<b>Subject:</b>  <b>CHECK ENGINE LIGHT ON WITH DTC P2183:00</b>	<b>Bulletin No.:</b> 01-011/17
	<b>Last Issued:</b> 08/25/2017

## BULLETIN NOTES

This bulletin supersedes the previously issued bulletin(s) listed below. The changes are noted below in Red.

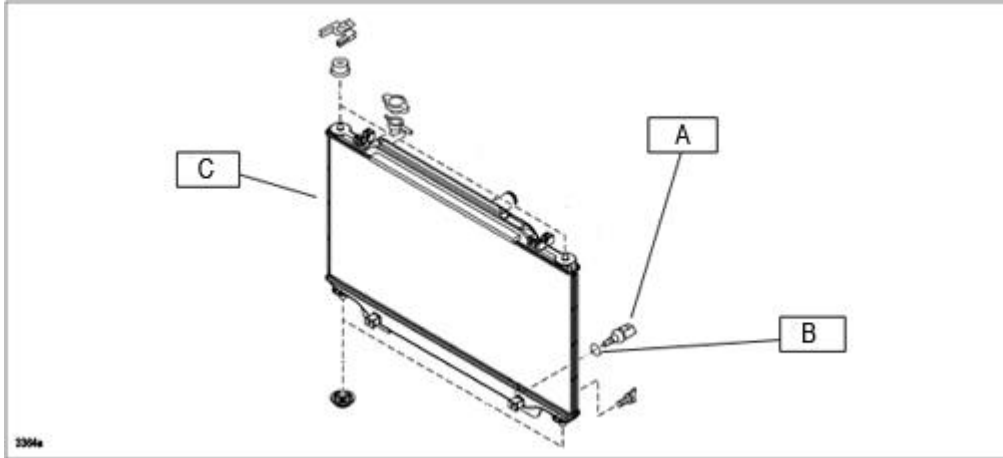
If the ECT sensor No.2 internal circuit is corroded, the sensor output is far below the ECT sensor No.1 output due to higher resistance caused by corrosion.

Determine if the ECT sensor No.2 is malfunctioning by comparing the two sensors outputs.

3.If the ECT sensor No.2 is determined to be "NO GOOD", replace it with a modified one according to the Workshop Manual "ENGINE COOLANT TEMPERATURE (ECT) SENSOR REMOVAL/INSTALLATION [SKYACTIV-G 2.0, SKYACTIV-G 2.5]."
